Subject: **Application for Modification to Section 404 Nationwide Permit, Section 401 Water Quality Certification and Neuse Riparian Buffer Certification:**  
Widening of Interstate 85 from west of Broad Street to west of Camden Avenue, Durham County, Division 5; Federal Aid Project No. I-85-4(49)174:  
TIP No. I-0306DB: \$475.00 Debit WBS Element 34143.1.7

Reference: USACE Action ID 200020902  
DWQ Project No. 001040

The purpose of this submittal is to request a modification to the Section 404 and Section 401 Water Quality Certification and Neuse Buffer Certificate. This modification is for changes to stream impacts. However, the revised permit drawings also depict other changes to the hydraulic design such as revisions to riparian buffer treatment devices, changes to structure layout, design and size, and rock planting in the riparian buffer.

N. C. DEPT. OF TRANSPORTATION  
 DIVISION OF HIGHWAYS  
 DURHAM COUNTY  
 PROJECT: 8.1414801 (I-0306DB)  
 I-85 FROM WEST OF BROAD  
 STREET TO WEST OF CAMDEN  
 AVENUE IN DURHAM  
 SHEET 4 OF 27 Rev 1/04

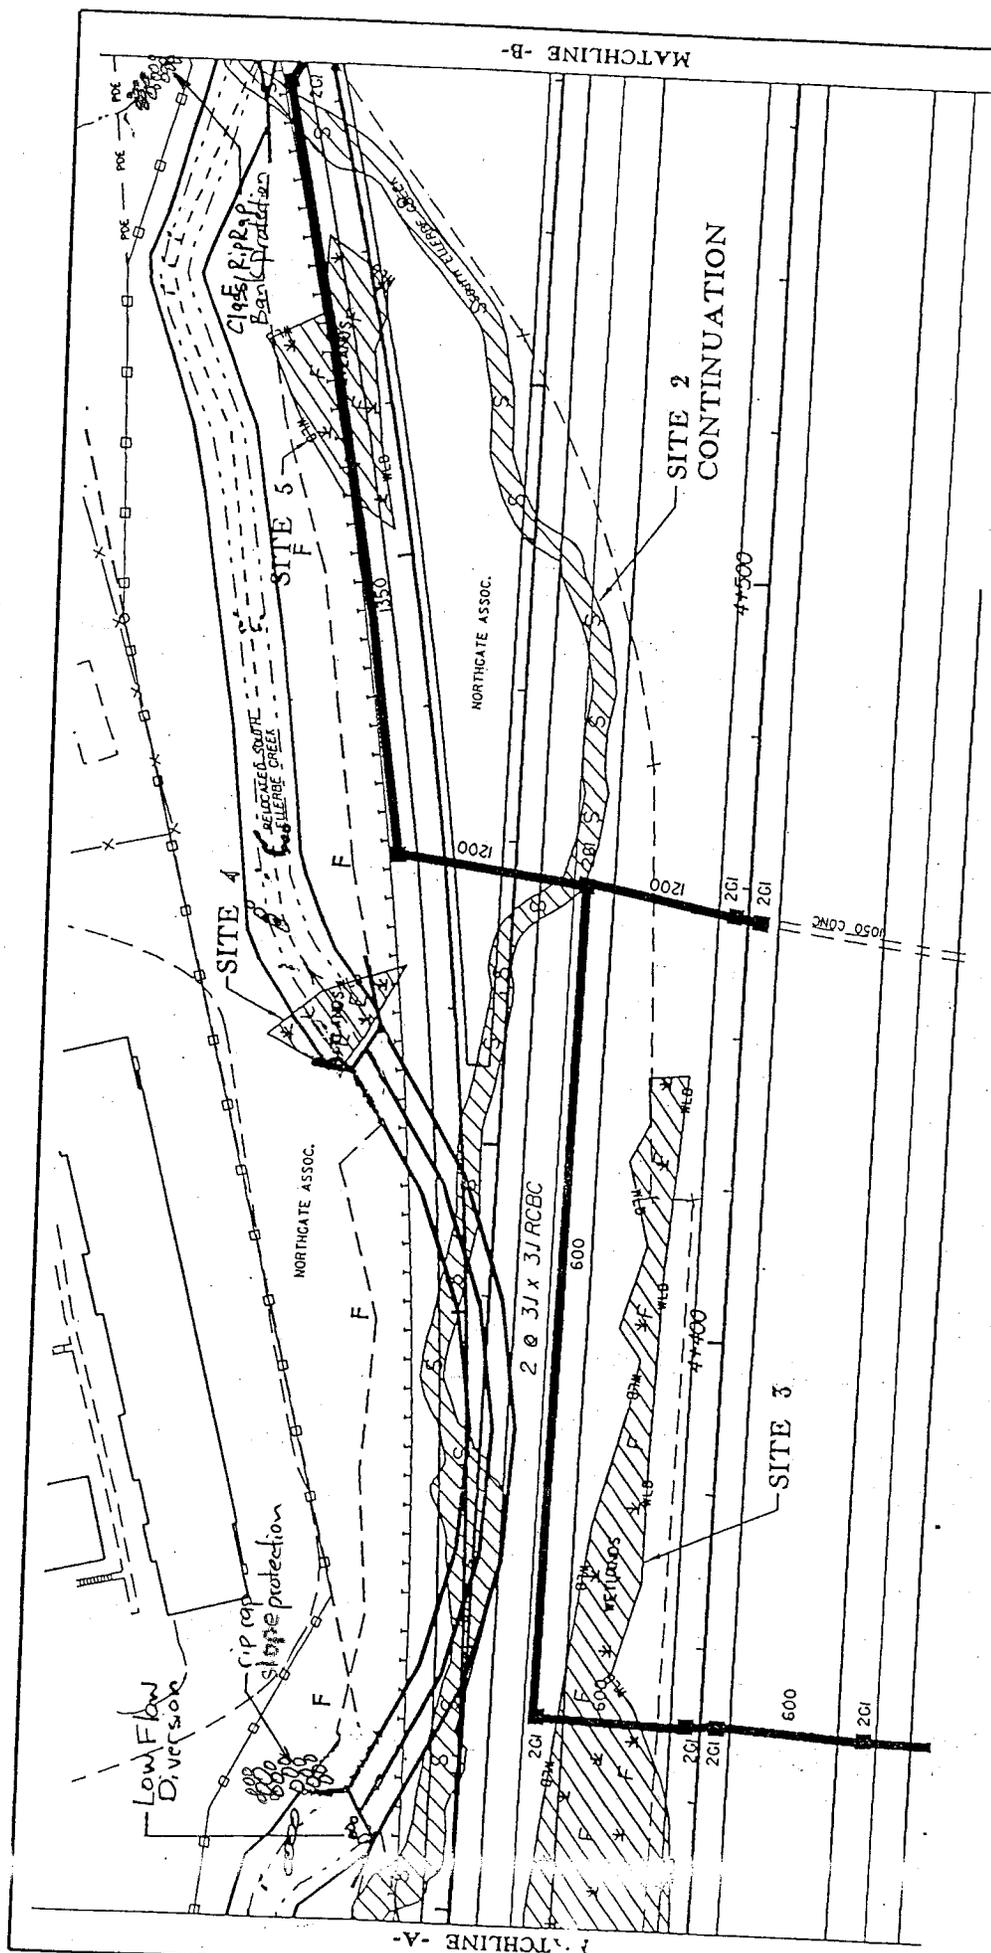
-Additional rip rap (approximately 7 linear meters (m)) at 3+320 Lt –LREV- has been installed along the east bank near the outlet of the structure in Zone 1 of the riparian buffer to provide for slope stability. No additional length of rip rap along the streambank has been installed beyond the limit depicted in the original permit drawing.

N. C. DEPT. OF TRANSPORTATION  
 DIVISION OF HIGHWAYS  
 DURHAM COUNTY  
 PROJECT: 8.1414801 (I-0306DB)  
 I-85 FROM WEST OF BROAD  
 STREET TO WEST OF CAMDEN  
 AVENUE IN DURHAM  
 SHEET 6 OF 27  
 REV. 3/05  
 REV. 1/04  
 Rev. 6/06

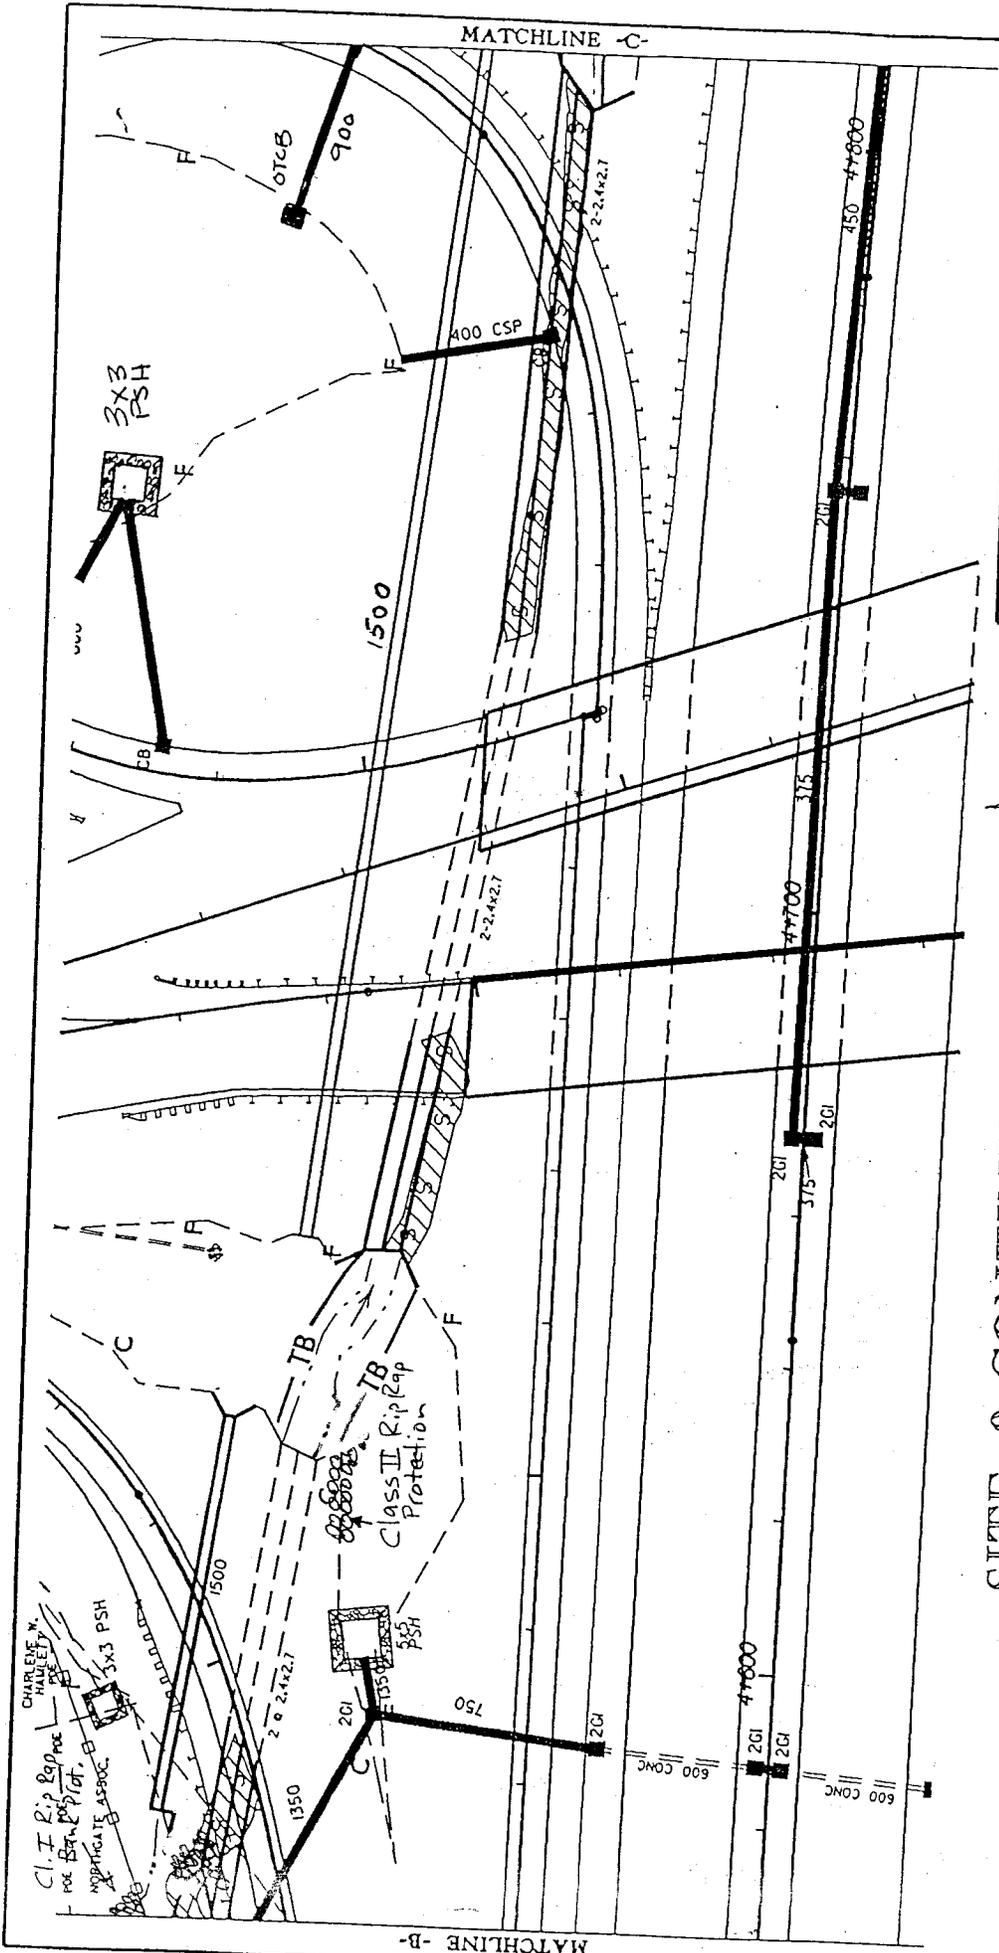
-The culvert inlet (near 4+330 Lt –LREV-) and outlet (near 4+430 Lt –LREV-) have been redesigned at a skew to provide a more normal flow. This will reduce the amount of relocated channel by 6 linear m.

-A low flow diversion, constructed of boulders, was added at the culvert inlet at 4+330 Lt –LREV- to direct low flows in the northernmost barrel.

-Additional rip rap (approximately 8 linear m) has been installed in Zone 1 of the riparian buffer to provide for slope stability at 4+330 Lt –LREV-.

-The rip rap for streambank stabilization identified at the culvert inlet (near 4+330 Lt –LREV-) and outlet (near 4+430 Lt –LREV-) on the original permit drawing has been deleted.

-An unnamed tributary to South Ellerbe Creek has been impacted by construction of the project at 4+560 Lt –LREV-. This tributary was not identified in the original permit drawings or roadway construction plan sheets. Rip rap will need to be placed along a portion of this channel to provide stability as it changes grade prior to entering the 1500 mm overflow structure. This will impact 10 linear m of stream. Note that this channel is also depicted on Sheet 7 of 27.

-A cross vane rock weir has been installed at 4+460 Lt –LREV-.

**\*\*Additional channel impacted at Site 2 on this permit drawing is 10 m.**

**\*\*Relocated channel at Site 2 on this permit drawing has been reduced by 6 m.**

N. C. DEPT. OF TRANSPORTATION  
 DIVISION OF HIGHWAYS  
 DURHAM COUNTY  
 PROJECT: 8.1414801 (I-0306DB)  
 I-85 FROM WEST OF BROAD  
 STREET TO WEST OF CAMDEN  
 AVENUE IN DURHAM  
 rev. 3/05  
 SHEET 7 OF 27 rev 1/04

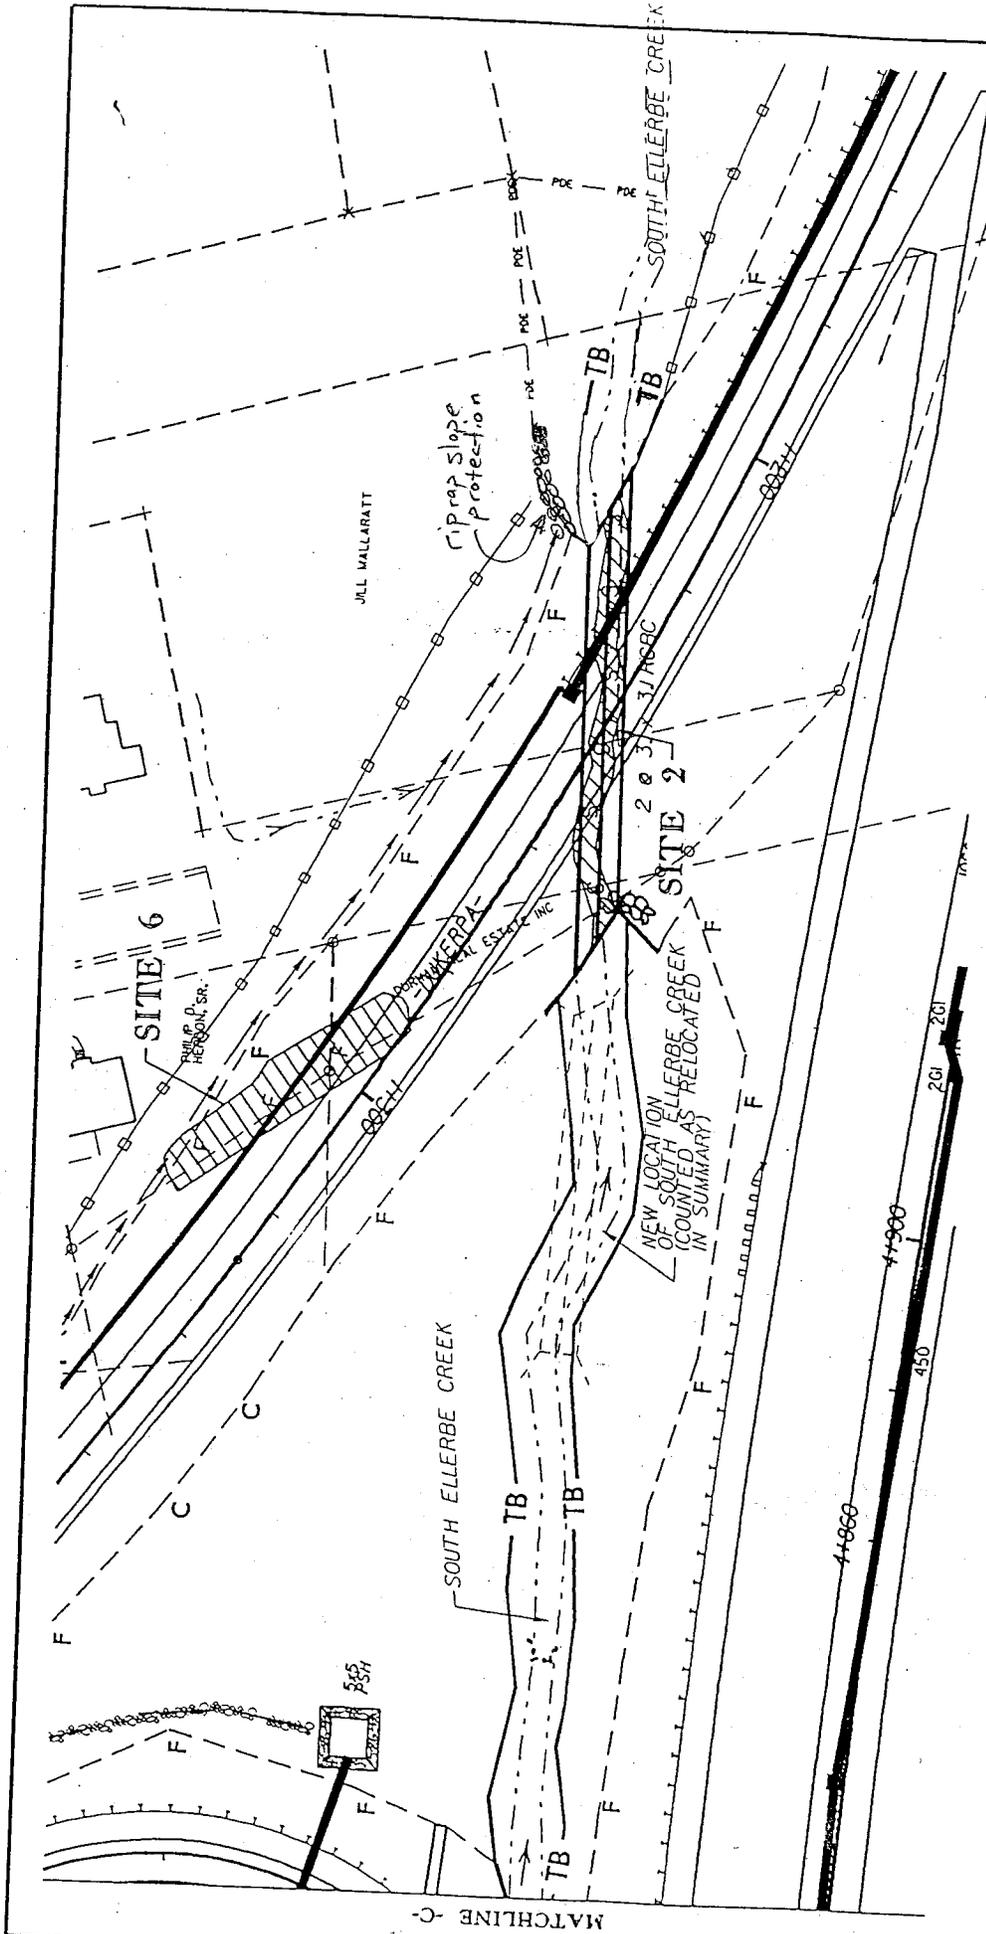
-A pre-formed scour hole has been added at 1+250 Lt –DUKELPA-. This device replaces a rip rap pad depicted on the original permit drawing.

-An open throat catch basin (OTCB) has been installed at the outlet of a structure at 1+100 Lt –DUKELPA-. The structure has been revised from a 600 mm pipe to a 900 mm pipe. The OTCB will serve as a stormwater detention device (note: a stormwater wetland has developed in this gore area).

N. C. DEPT. OF TRANSPORTATION  
 DIVISION OF HIGHWAYS  
 DURHAM COUNTY  
 PROJECT: 8.1414801 (I-0306DD)  
 I-85 FROM WEST OF BROAD  
 STREET TO WEST OF CAMDEN  
 AVENUE IN DURHAM  
 SHEET 8 OF 27  
 rev: 3/05  
 rev: 1/04

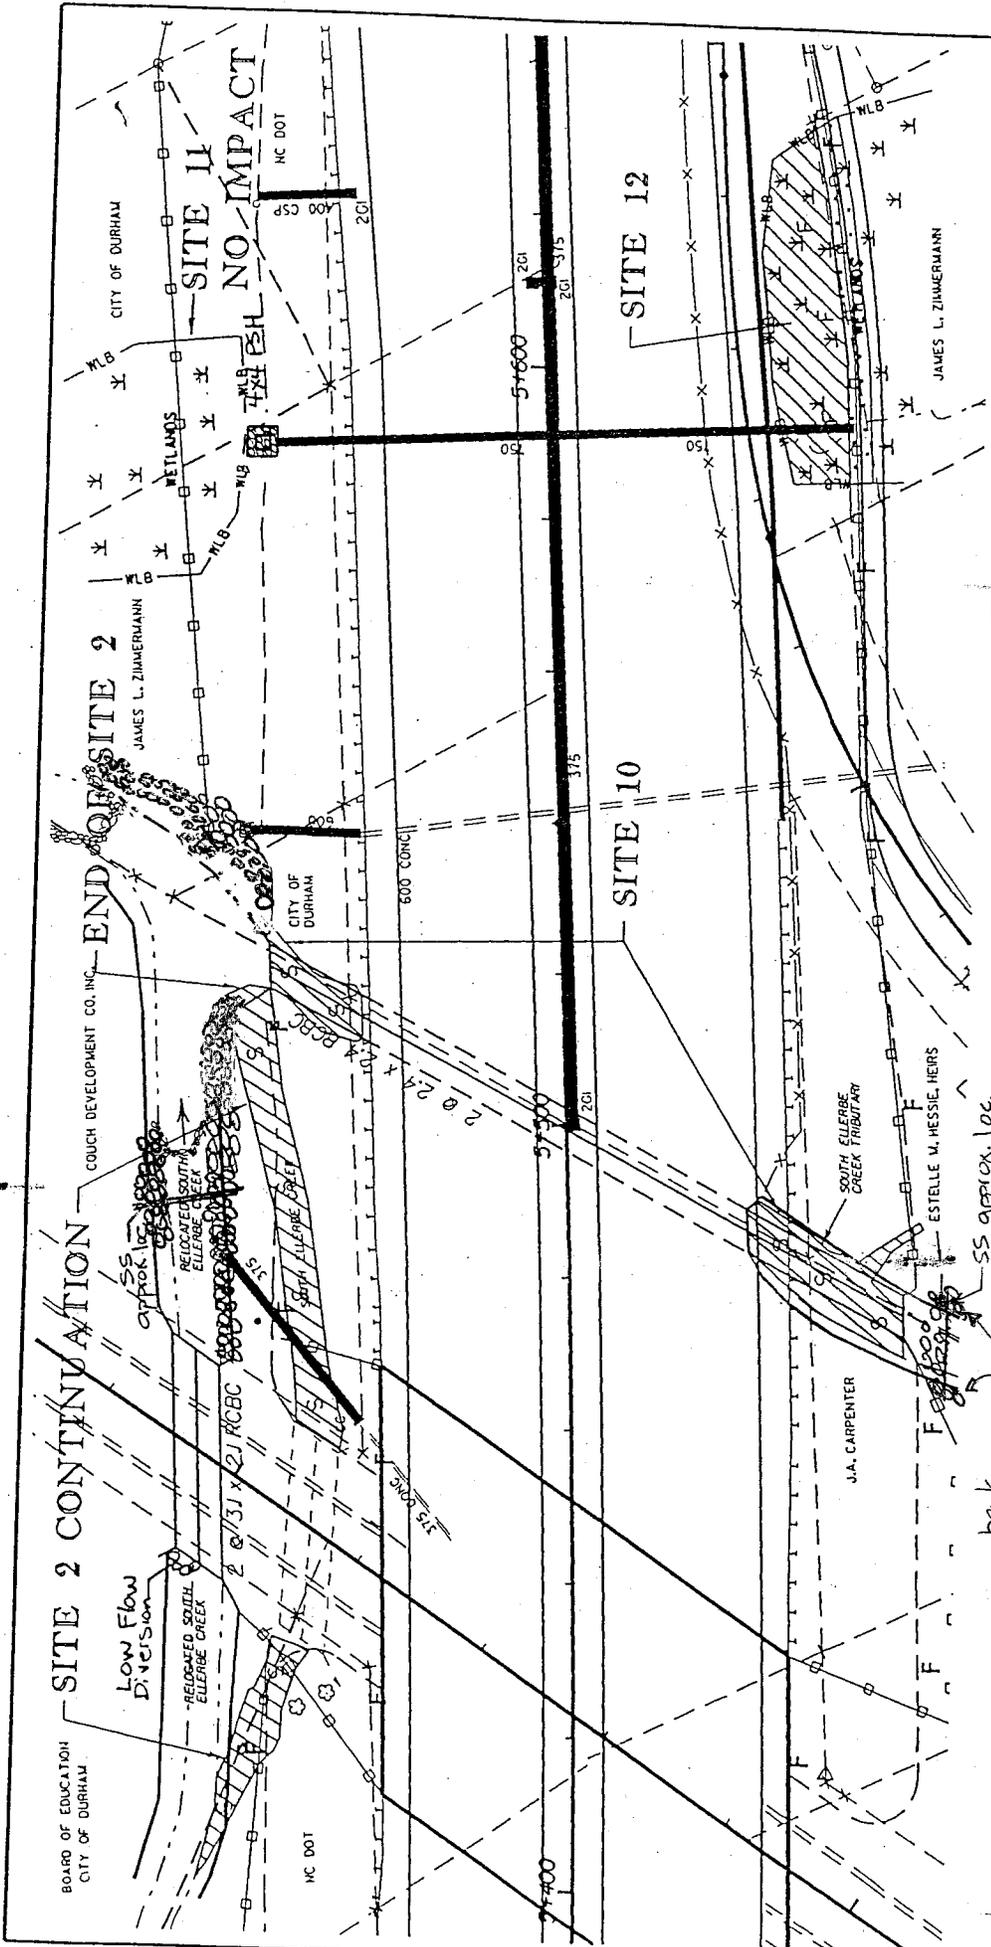
-The rip rap identified along the streambank at the culvert outlet at Station 1+220 Rt –DUKERPA- on the original permit drawing has been omitted. Additional rip rap (approximately 18 linear m) has been installed within Zone 1 of the riparian buffer for slope stabilization at this site.

N. C. DEPT. OF TRANSPORTATION  
 DIVISION OF HIGHWAYS  
 DURHAM COUNTY  
 PROJECT: 8.1414801 (I-0306DB)  
 I-85 FROM WEST OF BROAD  
 STREET TO WEST OF CAMDEN  
 AVENUE IN DURHAM,  
 rev. 3/05  
 SHEET 10 OF 27 rev. 1/04

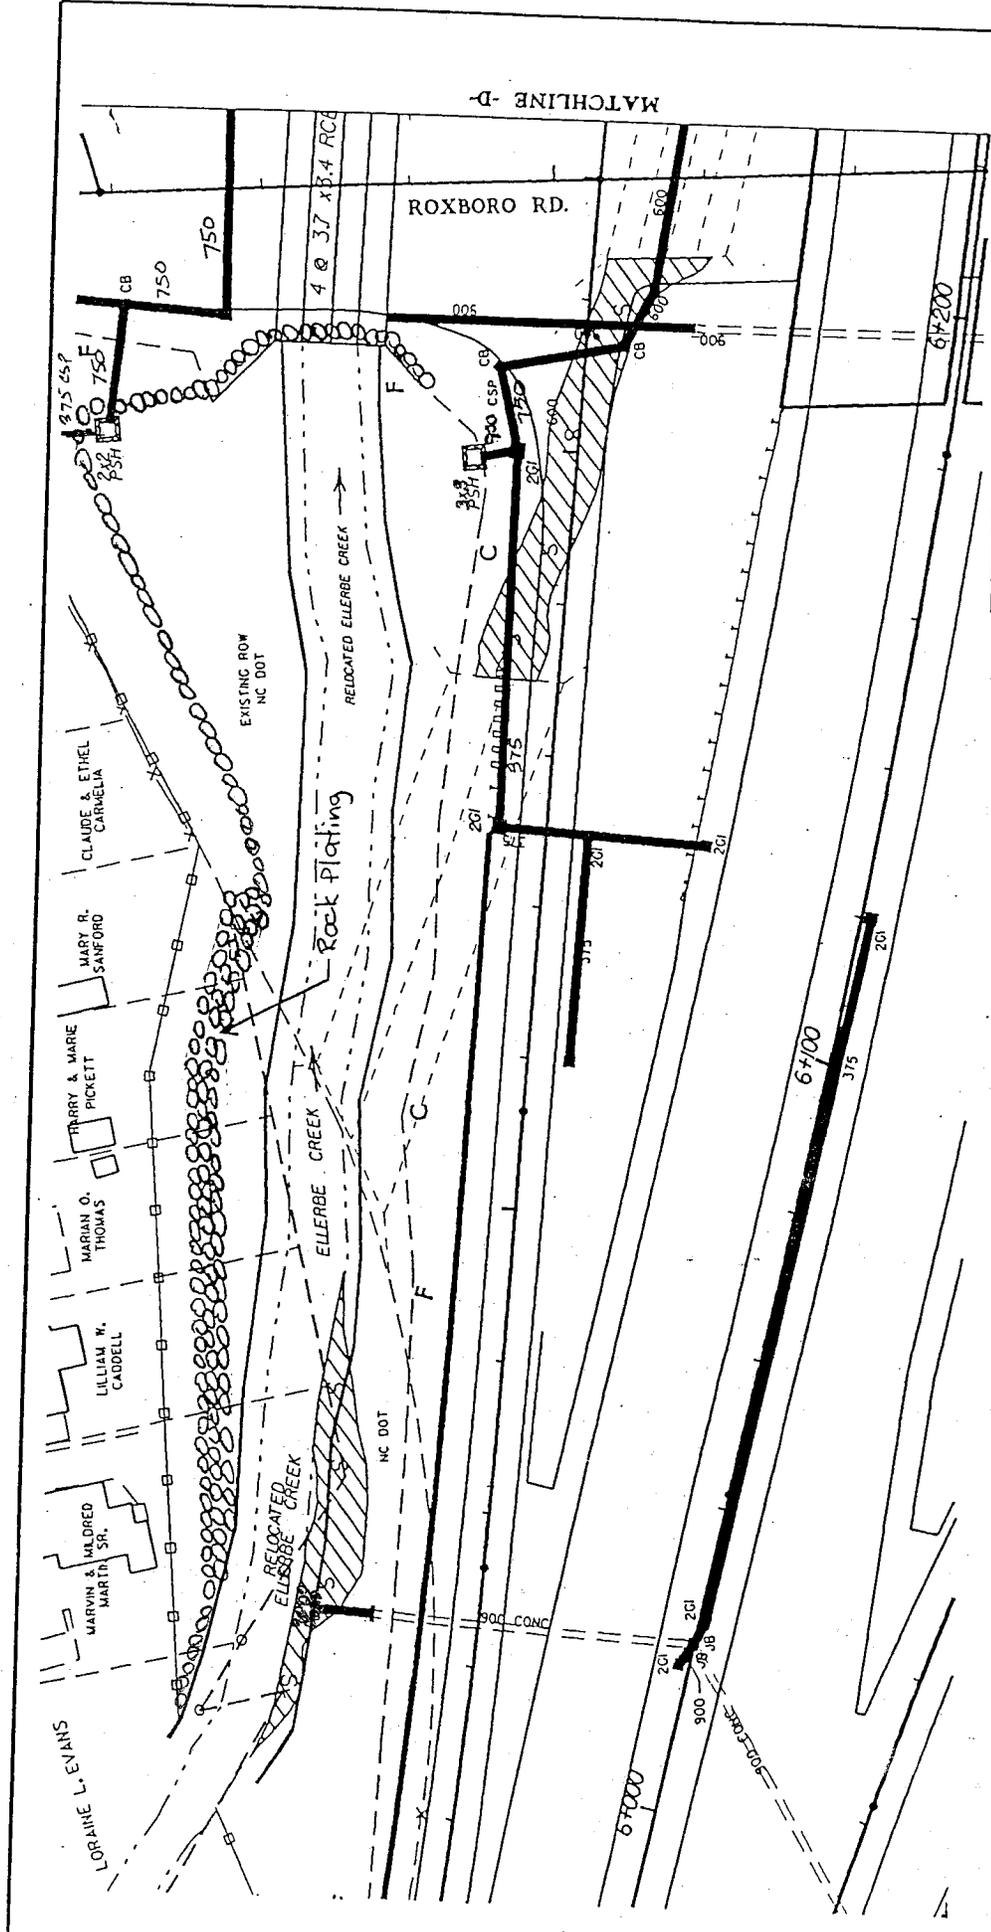
-A low flow diversion, constructed of boulders, was added at the culvert inlet at 5+440 Lt –LREV- to direct low flows in the southernmost barrel.

-Additional rip rap is required for streambank stabilization along relocated Ellerbe Creek at 5+465 to 5+515 Lt –LREV-. This rip rap is required to provide long-term stabilization around the outlet of a 375 mm structure, concrete footings of above-ground sewer crossing and the unstable north and south bank of relocated South Ellerbe Creek.

Please note that relocated South Ellerbe Creek in this location is in a high velocity area at its confluence with a tributary to South Ellerbe Creek. This will impact 50 linear m of relocated stream.

-Additional rip rap is required for streambank stabilization along Ellerbe Creek at 5+540 Lt –LREV-. This rip rap is required to provide stabilization around the outlet of a 600 mm structure.

This 600 mm structure has been conveying a substantial amount of water due to the presence of beavers located across I-85 at the inlet of the 600 mm structure. This will impact 3 linear m of stream.

-Additional rip rap (approximately 30 linear m) has been installed in Zone 1 of the riparian buffer to provide for slope stability at 5+530 to 5+550 Lt –LREV-.

-A pre-formed scour hole has been added 5+590 Lt –LREV-. This device replaces a rip rap pad depicted on the original permit drawing.

-Additional rip rap has been installed to provide streambank stabilization at an above-stream bed grade utility line crossing at an unnamed tributary to South Ellerbe Creek at 5+470 Rt –LREV-. This has impacted 5 m of stream.

**\*\*Additional channel impacted at Site 10 on this permit drawing is 8 linear m.**

**\*\*A total of 50 linear m of relocated South Ellerbe Creek will need to be stabilized with rip rap at Site 2 on this permit drawing.**
